DA2021/2557

## PROPOSED ALTERATIONS AND ADDITIONS

PARRY RESIDENCE

1A ELVINA AVENUE AVALON BEACH

OCTOBER 2021 DWG 1021 2/4 SHIMDESIGN design & drafting k2shimeld@gmail.com

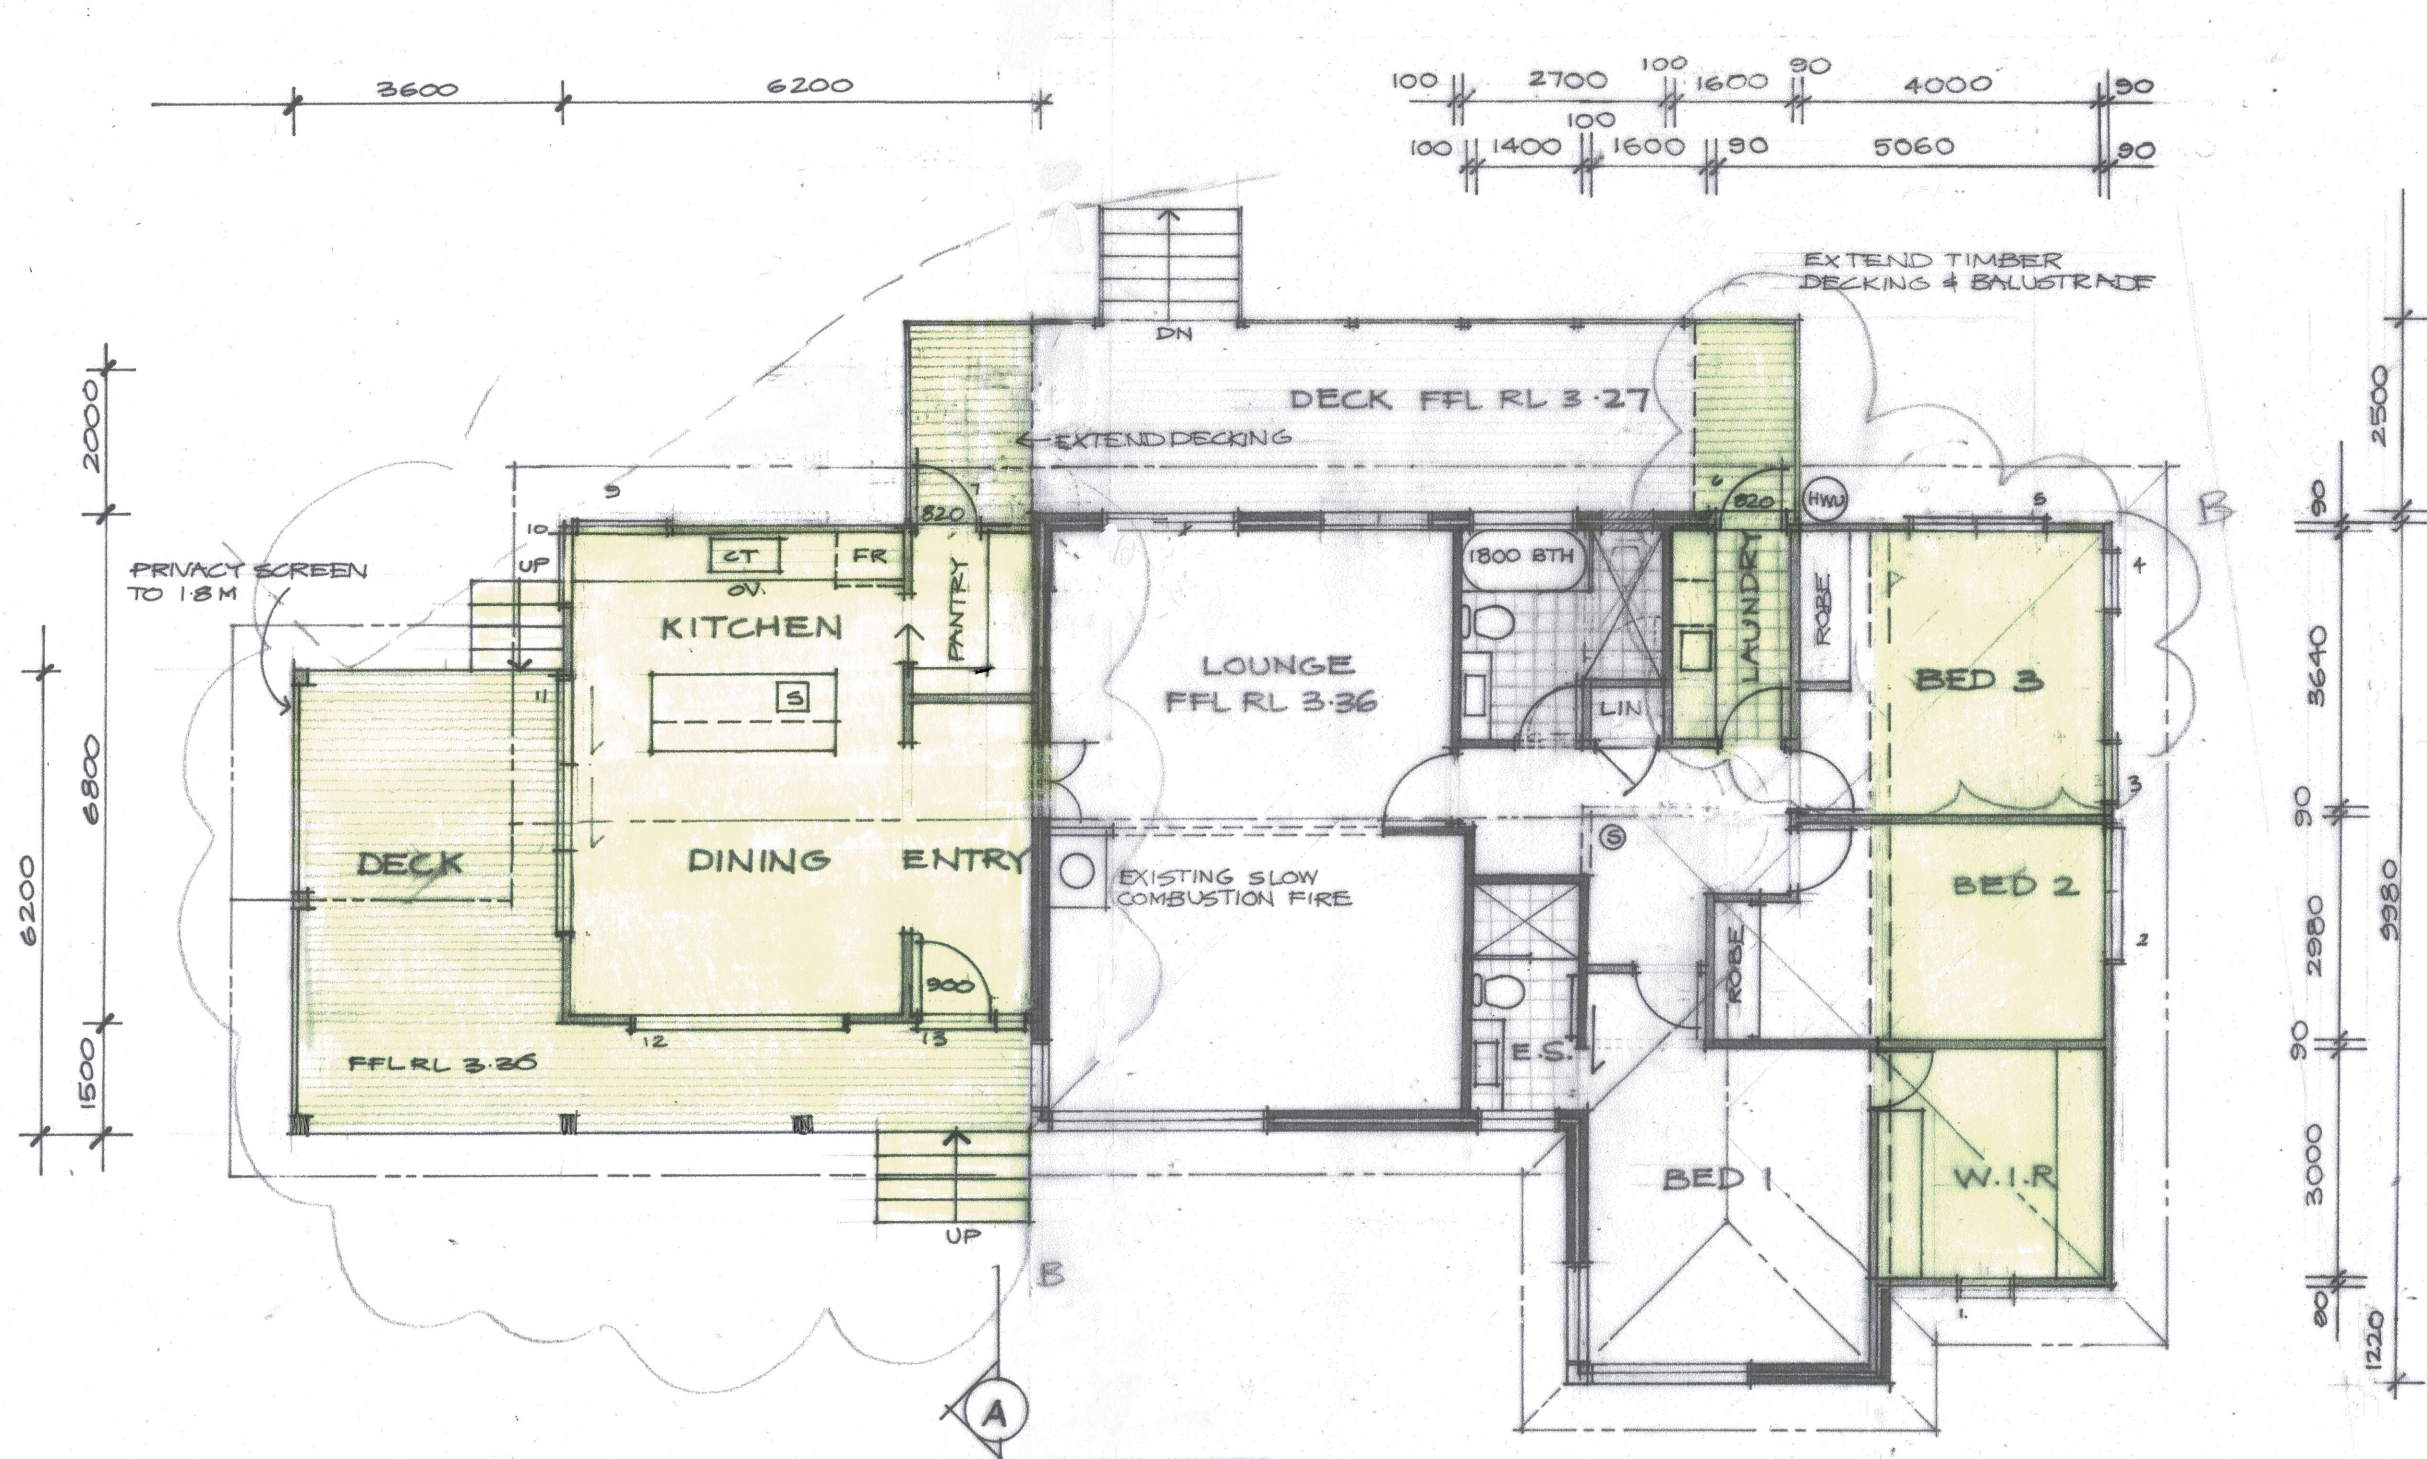
B. 25.5.22 KITCHEN / ENTRY / LAUNDRY - AVOID WETLANDS

**PROPOSED ALTERATIONS AND ADDITIONS**  
**PARRY RESIDENCE** 1A ELVINA AVENUE AVALON BEACH  
 OCTOBER 2021 DWG 1021 3/4 SHIMDESIGN design & drafting k2shimeld@gmail.com

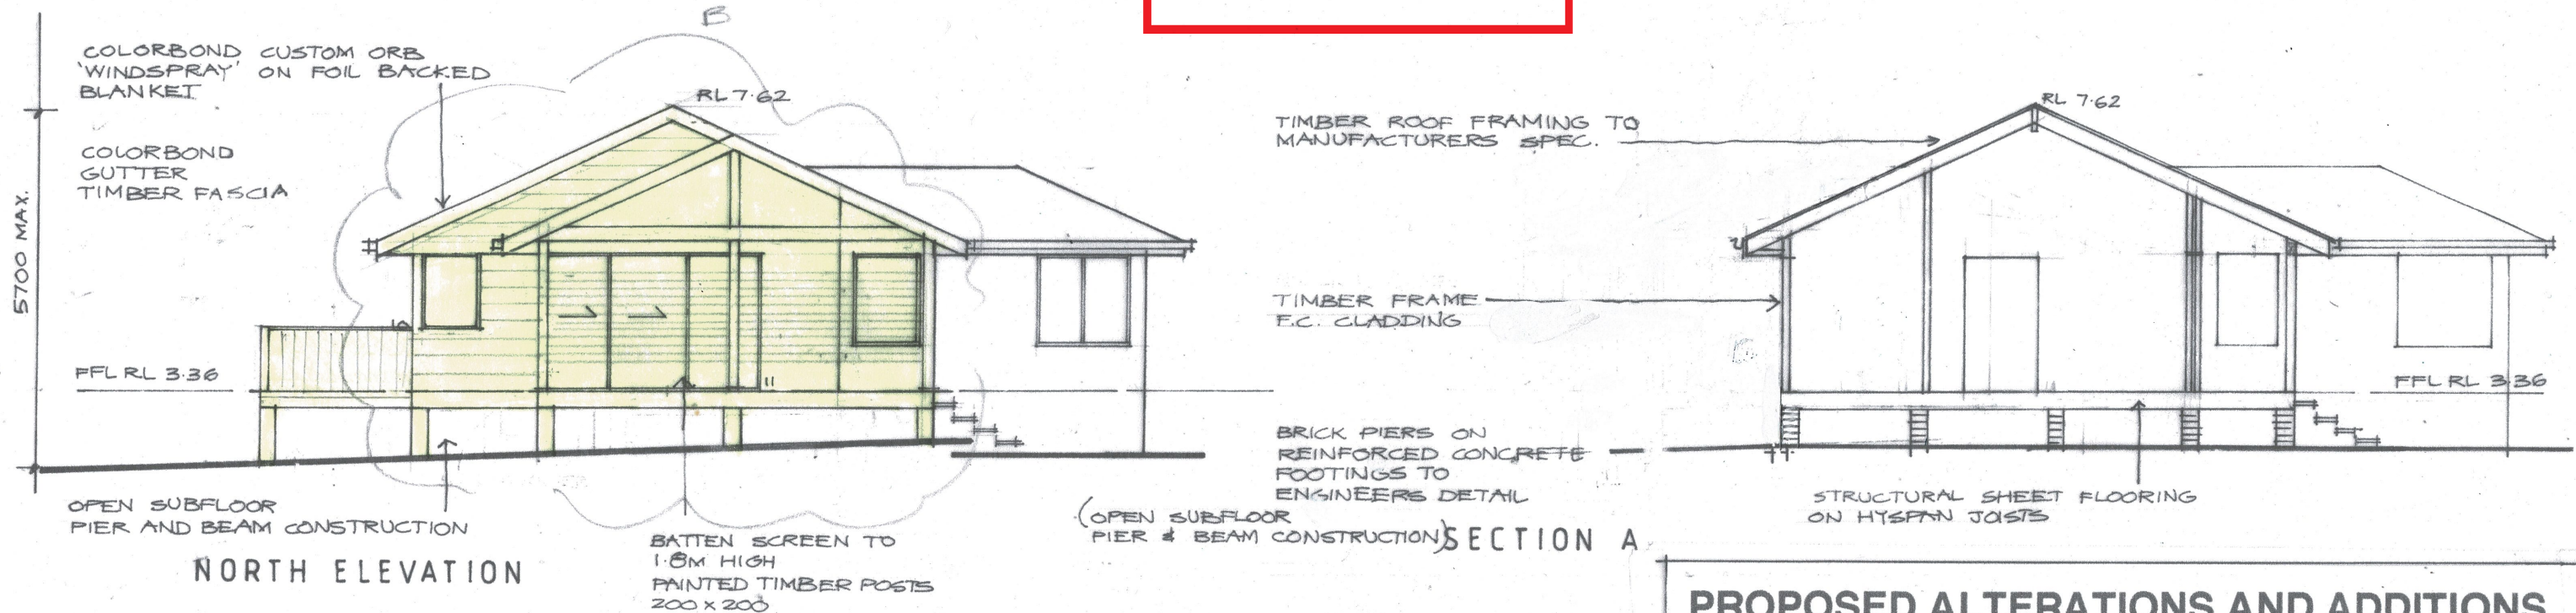
B, 25.4.22 AMENDED TO AVOID WETLANDS

**PROPOSED ALTERATIONS AND ADDITIONS**  
**PARRY RESIDENCE** 1A ELVINA AVENUE AVALON BEACH  
OCTOBER 2021 DWG 1021 4/4 SHIMDESIGN design & drafting k2shimeld@gmail.com

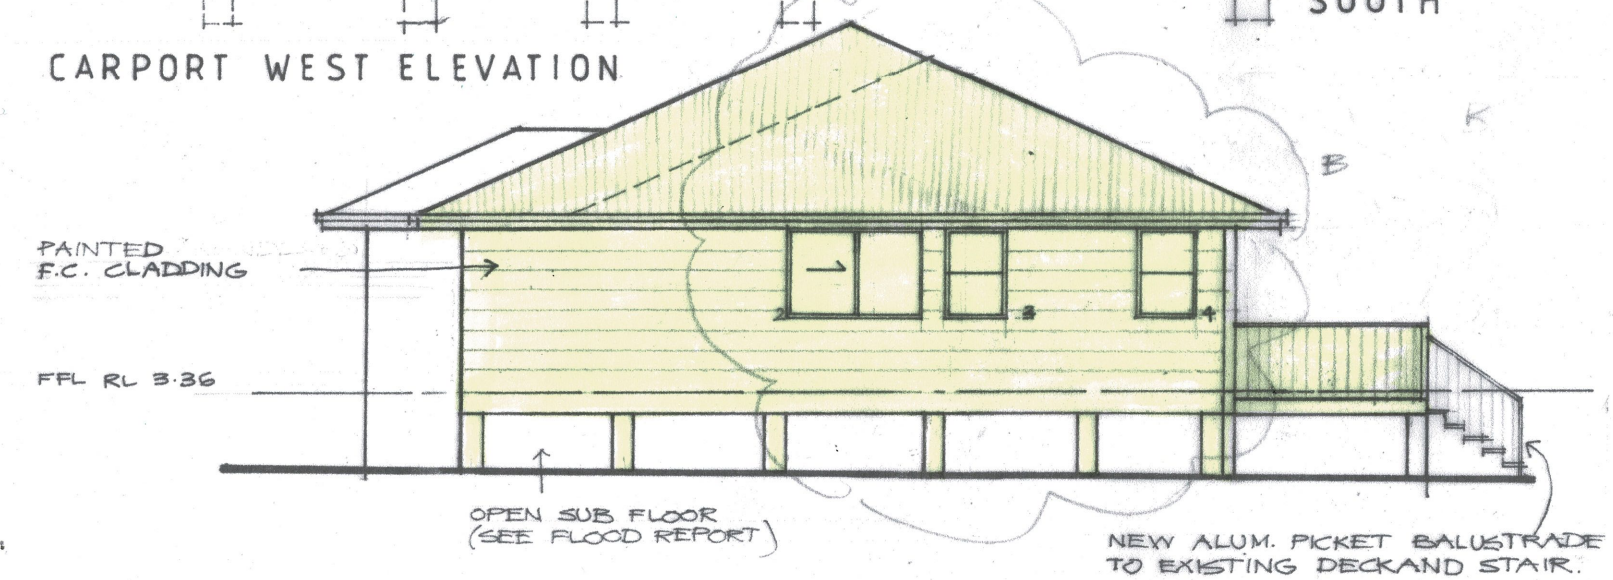
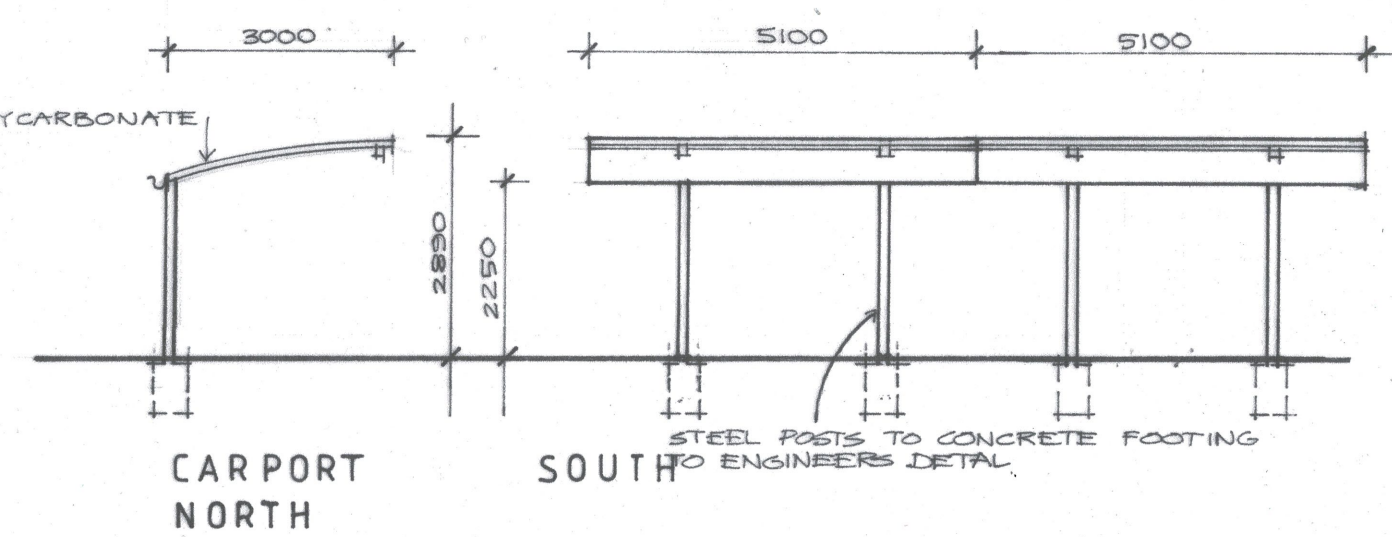
B. 25.5.22 REDUCE FOOTPRINT / AVOID WETLANDS  
A. 15.12.21 CARPORT ELEVATIONS
